SUBDIVISION COMMITTEE
METROPOLITAN AREA PLANNING COMMISSION

STAFF REPORT
(Final Plat)

CASE NUMBER: S/D 89-29 - THE VILLAGE AT WATERFORD

CASE NUMBER: S/D 89-29 - THE VILLAGE AT WATERFORD ADDITION

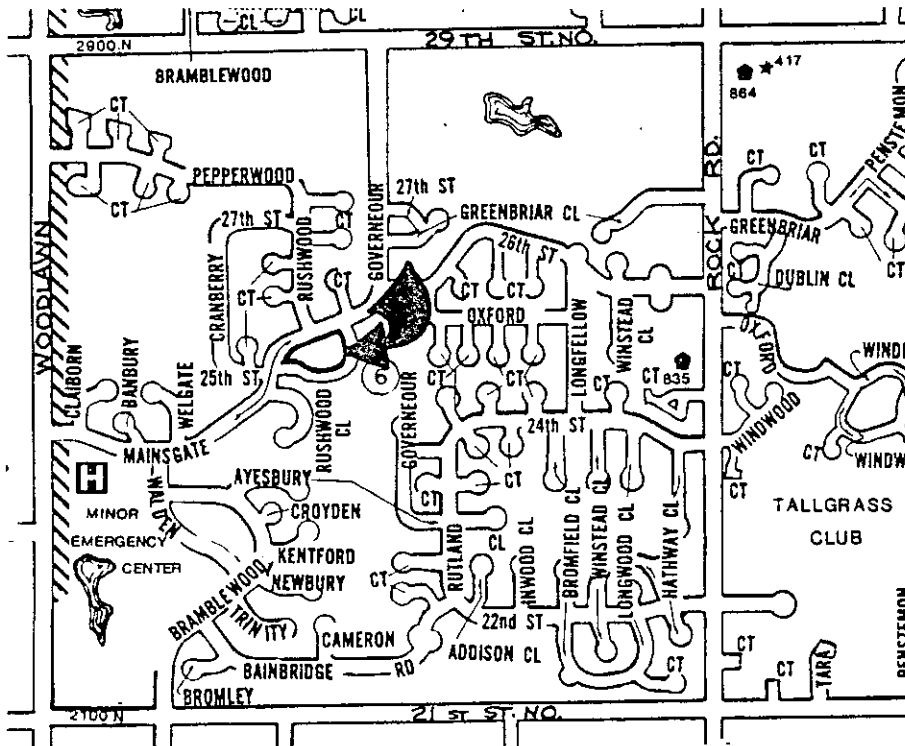
- NOTE: This property is subject to the provisions of the Comotara Residential Community Unit Plan (DP-73). This property is being replatted for development of typical single family homes, instead of zero-lot line development, and to clear sufficient area within Reserve "A: for construction of a swimming pool. This site was involved in a replat of the same name in 1987 and was approved by the City Council. The applicant however desired not to record the plat tracing and subsequently the case was closed.

- A. The applicant shall guarantee the paving of the proposed private interior streets to the 21-foot public street standard.
 - B. The applicant shall either abandon or amend the existing petitions on file for this property. If projects are to be abandoned as a result of this replat, the applicant shall pay off the charges against the abandoned projects.

- F. This plat is within parcel "3" of the associated C.U.P. (DP-73). Parcel 3 permits 121 dwelling units; the three additional lots in Reserve "A" will raise the potential of lots to 124. Therefore, the applicant must file for an administrative adjustment to insure that the proposed lot will correspond with the C.U.P. Further, it is our understanding that the area excepted out, from utility easements, in Reserve "A" is for the purpose of a swimming pool. This use will also require an amendment to the C.U.P. The final plat tracing shall not be submitted until the associated C.U.P. has been adjusted to permit the platting of three additional lots and a swimming pool in Parcel "3."

- H. On the final plat tracing the City Council signature block shall indicate "Bob Knight" and not "Robert G. Knight."
- I. Since the plat proposed the platting of narrow street rights-of-way with adjacent "20-foot public drainage, utility and private street easement," a restrictive covenant shall be submitted which calls out restrictions for lot-owner use of these easements. Retaining walls and change of grade shall be prohibited within these easements as well as fences, earth berms and mass plantings. Any planting within this easement shall be reviewed by the City Forestry Division prior to installation.

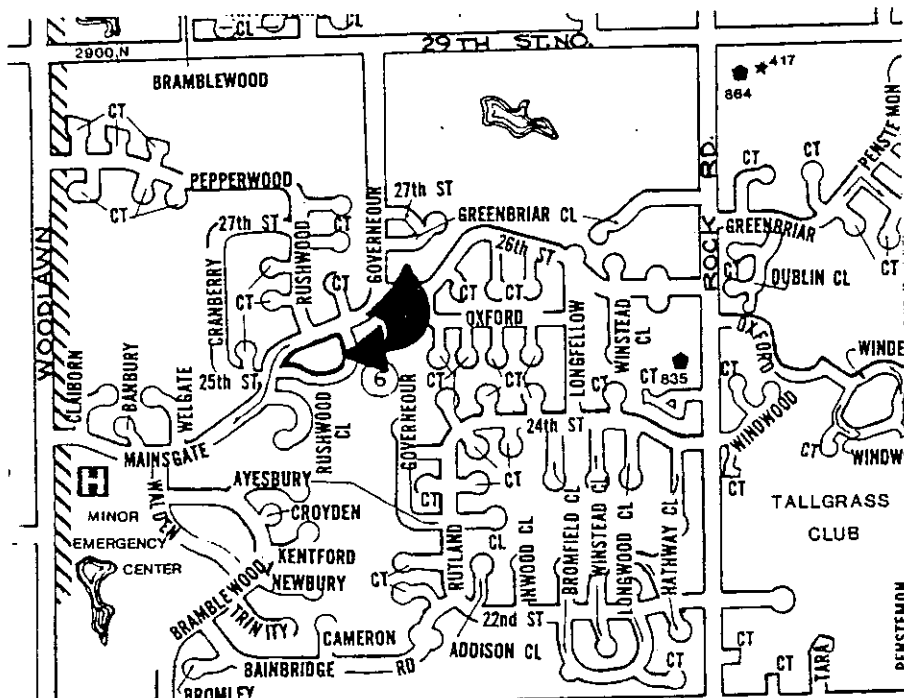
- H. As indicated by the CUP, DP-73, lots adjacent to collectors such as Mainsgate are required to have a 25-foot building setback. Since there are no conditions under which any other setback would apply, Lots 1, 2 & 3 shall show on the final plat tracing, a platted 25-foot building setback to Mainsgate.

- I. On the final plat tracing, the centerline (CL) of Mainsgate shall be labeled and the amount of half-street right-of-way shall also be indicated.
- J. The applicant shall install or guarantee the installation of all utilities and facilities which are applicable and described in Article 8 of the MAPC Subdivision Regulations.

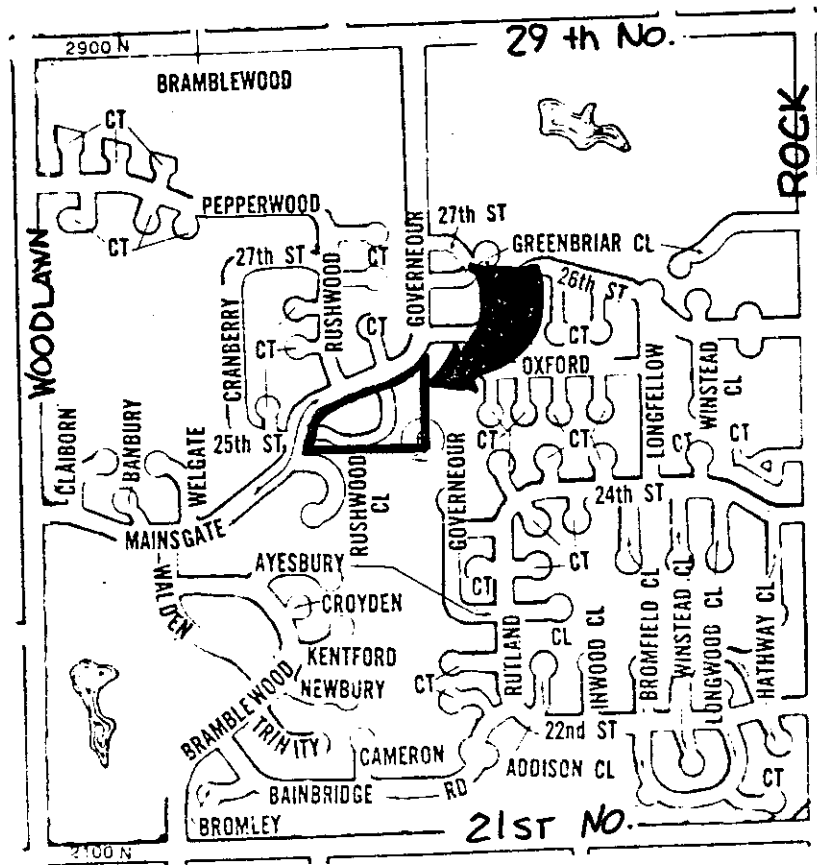
- L. On the final plat tracing, the plattor's text shall be amended to reference the platting of the parking easements within Reserve B.
- M. On the final plat tracing, the centerline of adjacent Mainsgate Street shall be labeled.

- N. On the final plat tracing, the intersections of 25th Street North and Mainsgate and Cameron and Mainsgate shall be denoted with a heavy line as opposed to a dashed line. This is needed to denote the perimeter of Reserve C (private street).

- O. The final plat tracing shall omit the platting of a joint "utility and maintenance easement" (Lots 2 and 3, Block 1). Roof overhangs are not permitted within utility easements.

- W. As indicated on the final plat, the applicant proposes to plat three parking easements within Reserve B. The representative from City Engineering should be prepared to comment on the acceptability of the parking easement locations. Specifically, should the parking easement near Lot 7 be moved away from the private street curve?
